## **Value Engineering** Final Report

# **Hogback Diversion Dam – Fish Screen Project**

**Friday, July 20 2007**

Figure 4. Site Layout for Proposal No. 1a

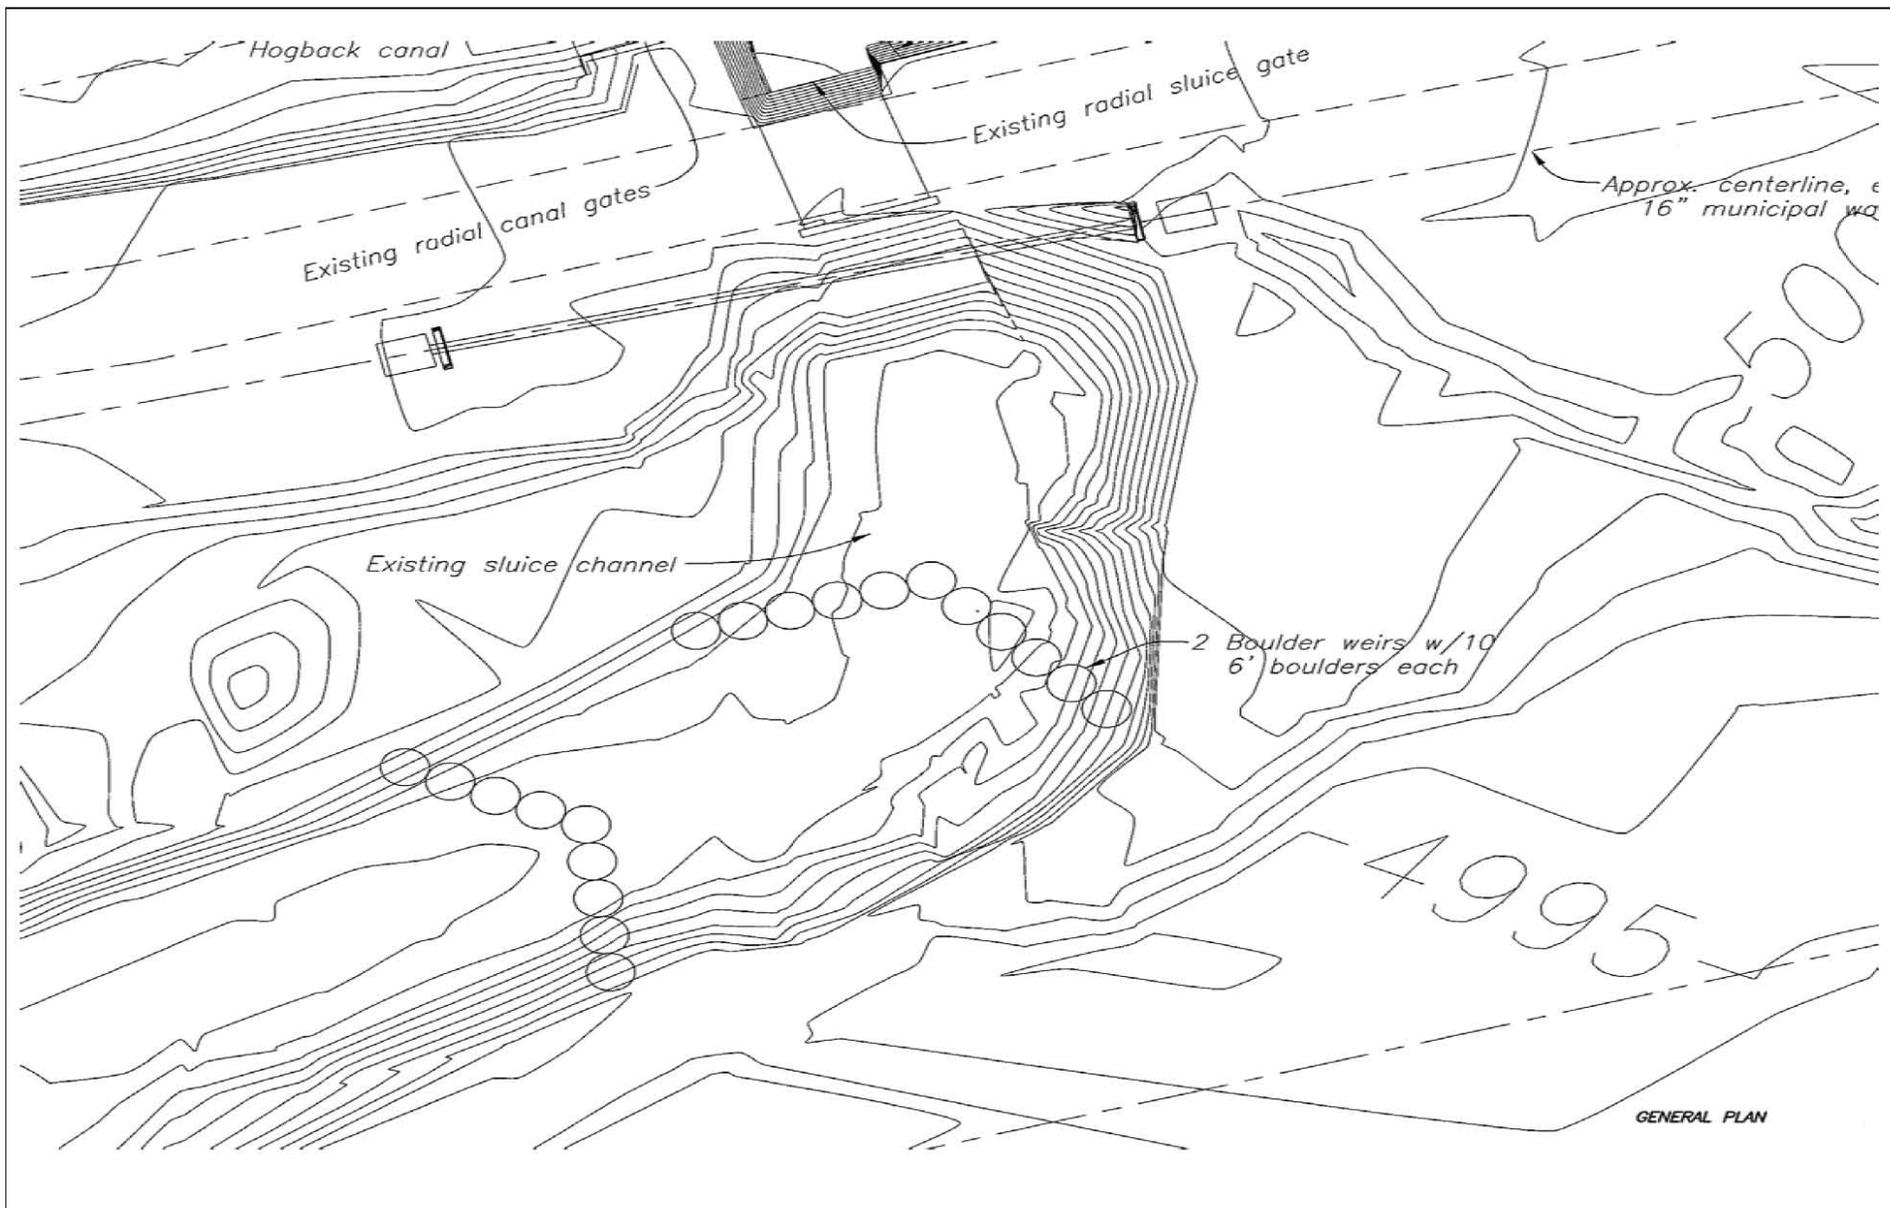
Proposal Description: This proposal consists of placing geotextile and riprap in the upper portion of the sluice channel and placing two rows of boulder weirs in the channel to produce a stilling pool for protecting the fish that leave the sluice gate.

Critical Items to Consider: The current configuration for the sluice return channel results in a high velocity, turbulent exit of water from the canal. Given the maximum diversion of up to approximately 650 cfs from the San Juan River by the Hogback Canal headworks and the intended canal diversion downstream of 230 cfs, the sluice return channel consistently receives high flow. The sluice return channel exits the canal at a right angle and then makes a subsequent right angle turn en route to confluence with the San Juan River. The sluice gate allows for both bottom and top release of diverted water. While the top (overflow of gate) release is of low velocity, the predominately bottom release controlled by the sluice gate results in high velocities that enter the sluice return bed in a turbulent fashion that is injurious to fish.

A hydraulic analysis is recommended to adequately size the channel restrictions to adequately provide the necessary tailwater and hydraulic conditions for the fish while maintaining an effective sluice capability of the existing canal.

Ways to Implement: Modifications to the sluice return channel and/or sluice gate should include reduction of water velocity and turbulence. This can be accomplished by a combination of actions, including velocity reduction through modification of the sluice gate and its operation. Creation of a 'stilling' basin or pool immediately downstream of the gate and other instream modifications will reduce velocity and turbulence.

Changes from the Baseline Concept: This requires modification to sluice gate and/or sluice return channel to reduce water velocity and turbulence.

Figure 5. Site Layout for Proposal No. 1b

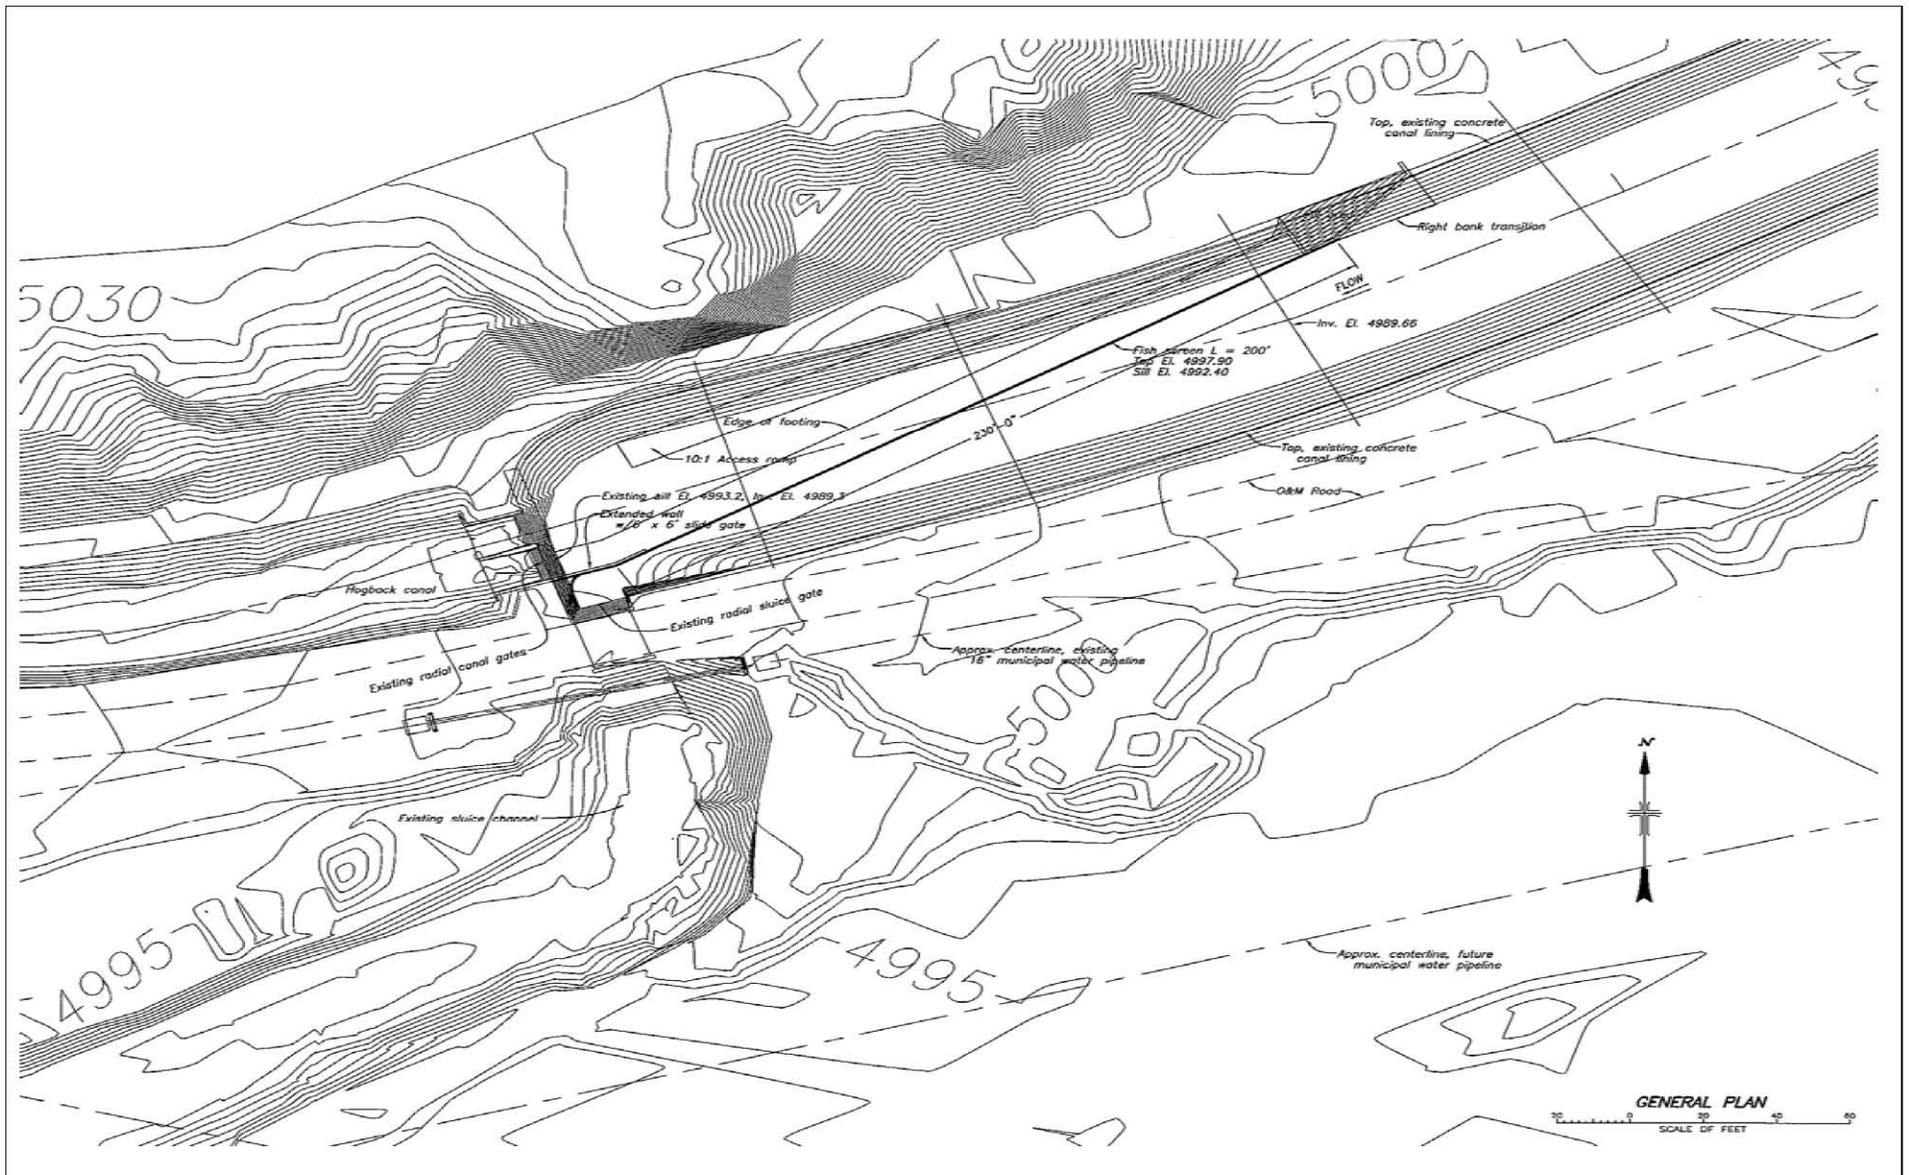
Proposal Description: This proposal consists of providing an equipment access ramp on the back side of the fish screen and adding a concrete wall and slide gate at the end of the screen. The access ramp would be approximately 8 feet wide and would slope from the top of the canal lining down to invert on a slope of approximately 10:1.

The additional concrete wall would be constructed at the end of the fish screen and extend to the existing headwall at the existing canal radial gate structure. The wall is proposed to prevent water flow from behind the screens towards the open sluice gates. The wall is assumed to be 12 inches thick and approximately 20 feet long. A 72-inch by 72-inch gate would be installed in the wall to assist in removing silt from behind the screens. The 72-inch gate would have an electrical gate operator. This gate would also assist returning accumulated fish from behind the screen to the sluice channel and river.

Figure 6. Changes to Existing Trashrack

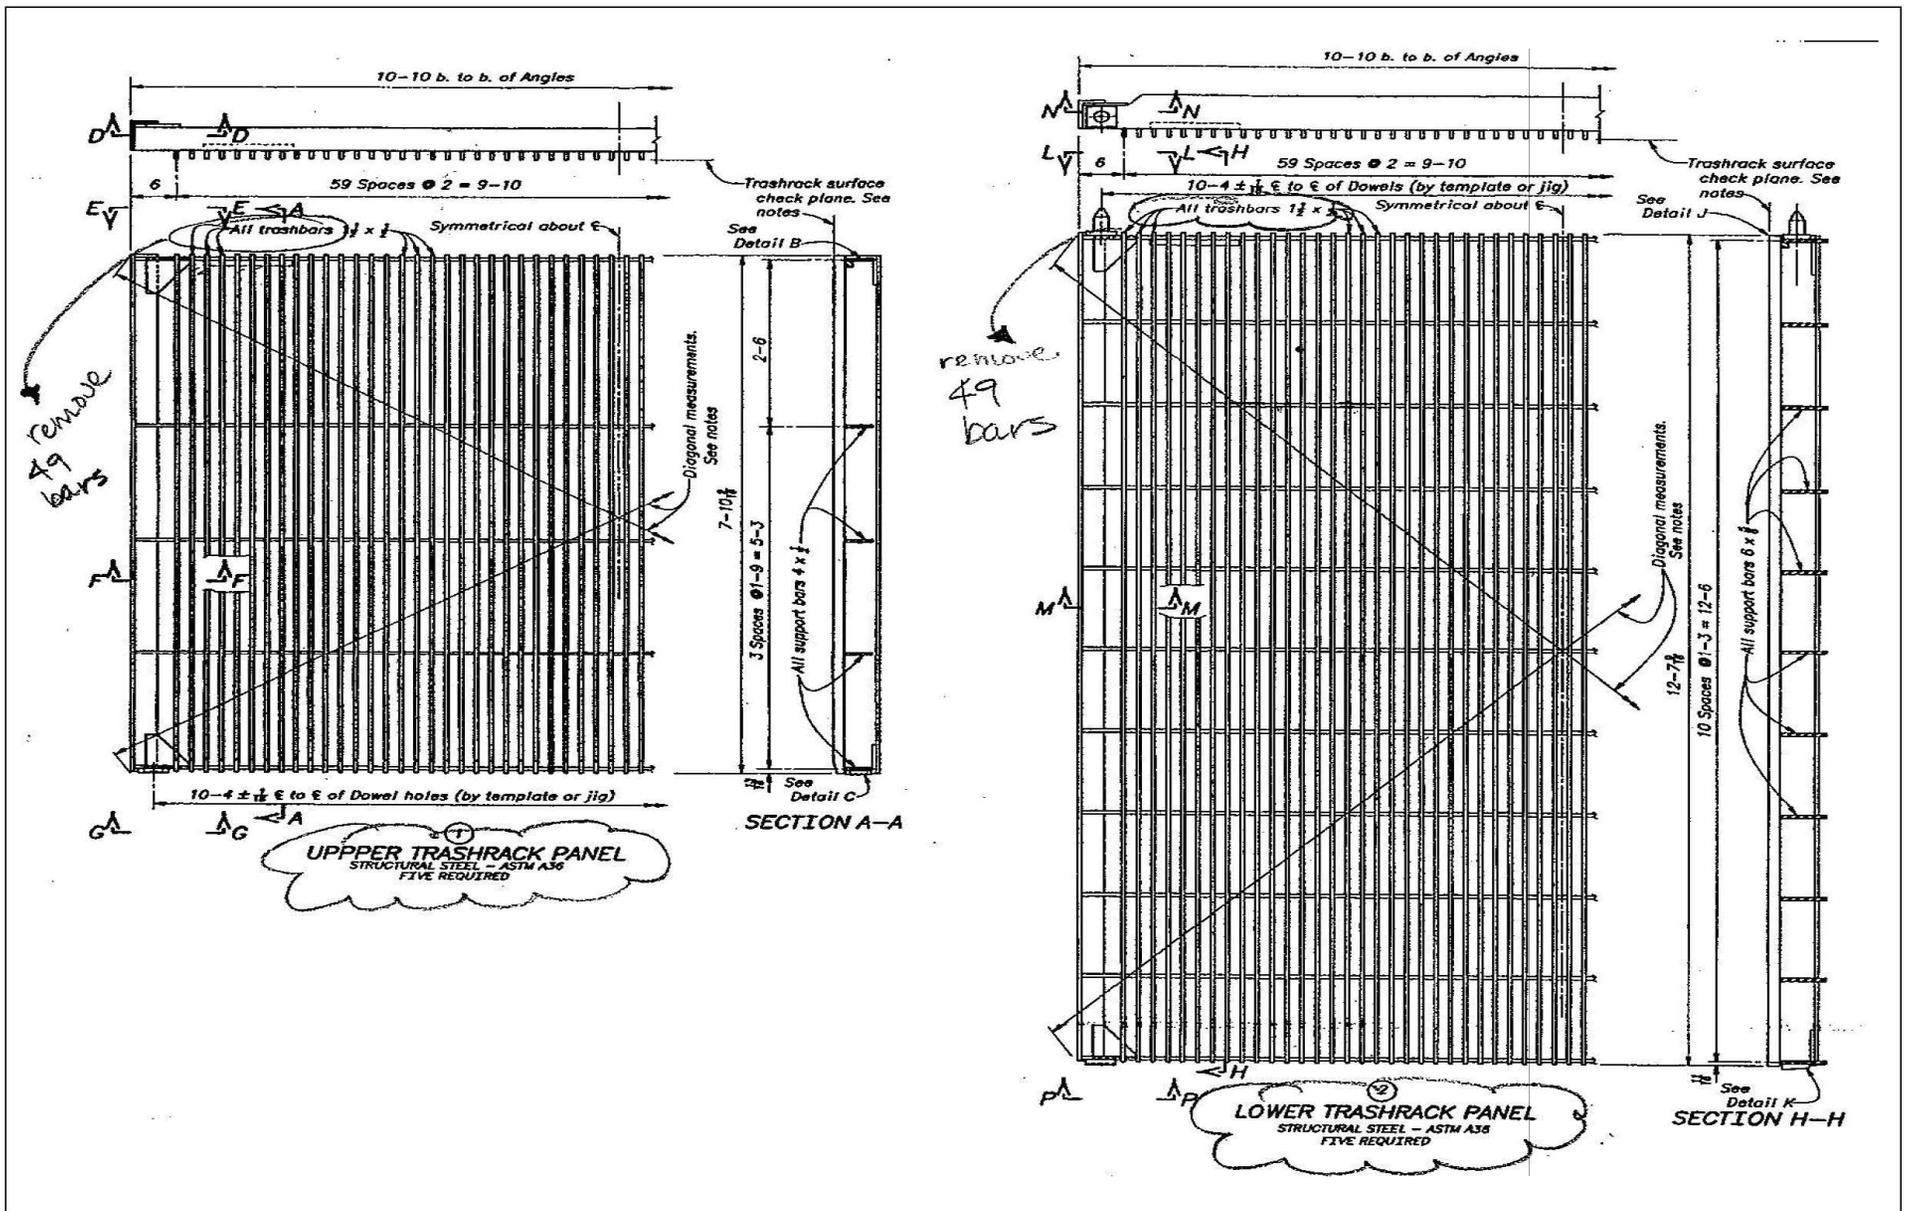
Proposal Description: Proposal 1f eliminates the trash rake and conveyor at this location and modifies the existing trashracks to catch the large debris.

Critical Items to Consider: The approach velocity to the trashracks exceeds the recommended approach velocity for the trash rake that is in the baseline design (single boom rake unit). The angle at which the flow approaches the trashracks may also present problems for the trash rake. If a trash rake was installed at this location, a larger trash rake would be necessary.

The trashracks need to be modified and the work involved may be very labor intensive. The cost of the modification to the trashracks may be similar to fabricating new trashracks.

Ways to Implement: Remove trashracks from the location and take to a shop. Have a contractor remove 49 trash bars from each panel so that the spacing between the trash bars is 12 inches versus the existing 2 inches between each trash bar. By increasing the spaces between the trash bars, the amount of debris that collects at this structure will be reduced to a manageable quantity that the O&M staff is able to redirect or manually remove.

Changes from the Baseline Concept: Eliminate the trash rake and conveyor and modify or replace the trashracks.

Figure 7. Site Layout for Proposal No. 1g

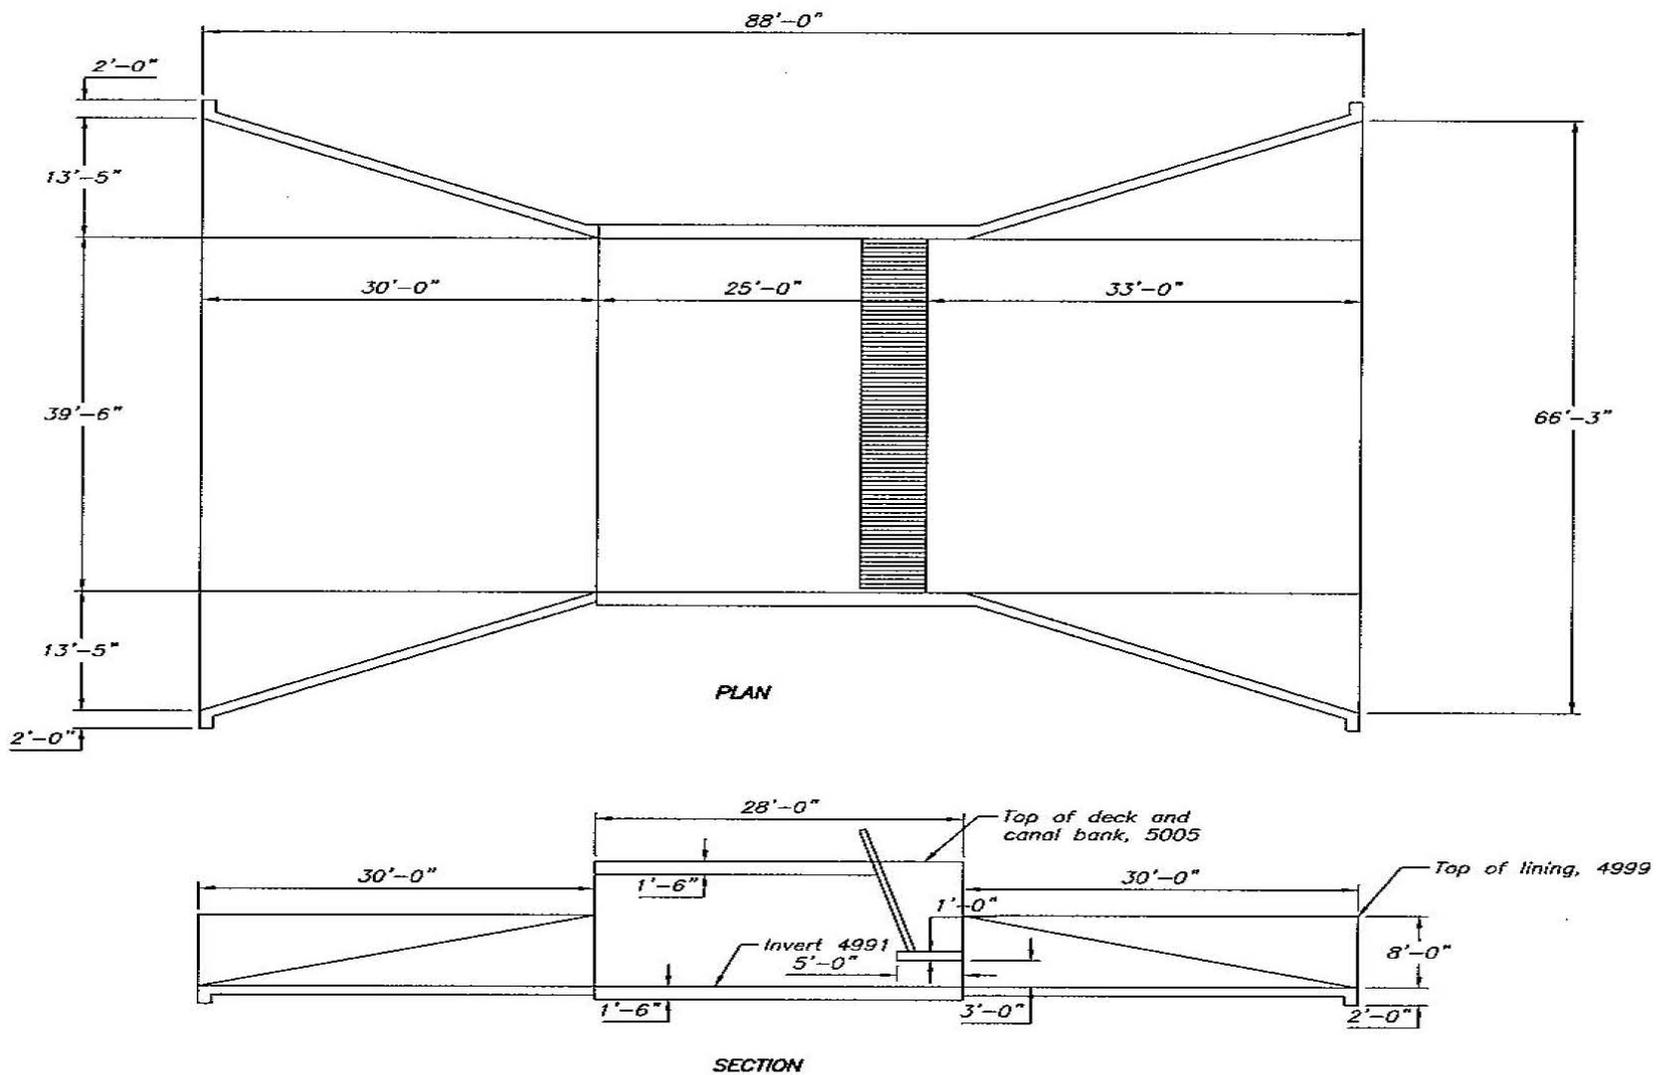
Proposal Description: This proposal provides for a structure and trashracks in the canal and a trash rake at the structure.

The debris will collect on the deck necessitating the need to manually push the debris off the deck but will eliminate the need for a conveyor. The larger debris will be caught at the Headwork trashracks and smaller debris will be removed from the canal using a single boom trash rake. The deck will be accessible to vehicular traffic.

Critical Items to Consider: A new structure will need to be constructed; including trashracks and installation of a trash rake. The O&M crew will need to periodically visit the site and push accumulated debris off the deck. Depending on the time of the season, this could be a daily maintenance task.

Due to the size of the material being transported by the river during high runoff, the team strongly recommends that proposal 1f be accepted in combination with this proposal.

Ways to Implement: Design a deck and structure to accommodate the trash rake and vehicular traffic. Install trash rake and racks. Power needs to be brought to the location to operate the trash rake. Provide a skid steer to push debris off deck.

Changes from the Baseline Concept: Move trash rake from headworks structure to a location in the canal that is upstream of the traveling fish screens. Eliminate conveyor and provide a "Bobcat" to push debris off deck.
